BULLETIN #133 Rev.A

### CONSTRUCTOR WF22 - MILLER S22A CONTROL CABLE CONNECTIONS CONTROL CABLE IN AM 264-0 KIT

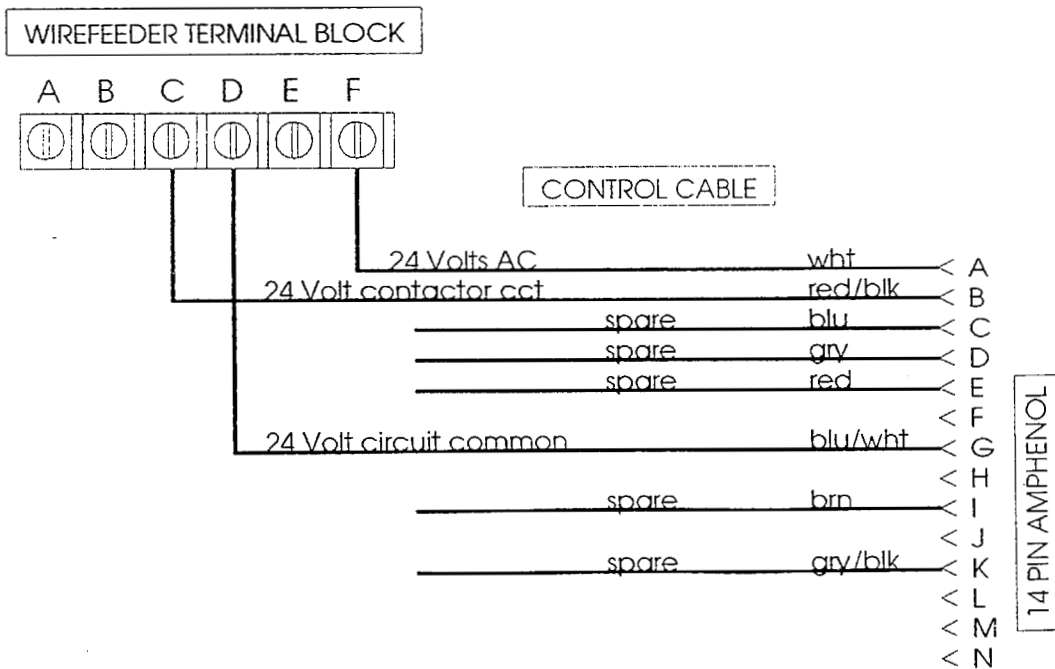
This bulletin replaces previously issued bulletin #133 (October 1995). The wiring information in that bulletin was incorrect !

When fitting the control cable to a WF22 / S22, the three wires terminated with spade lugs should be fitted as shown below. The remaining five wires are only required for some wirefeeder options, and should be otherwise taped-off.
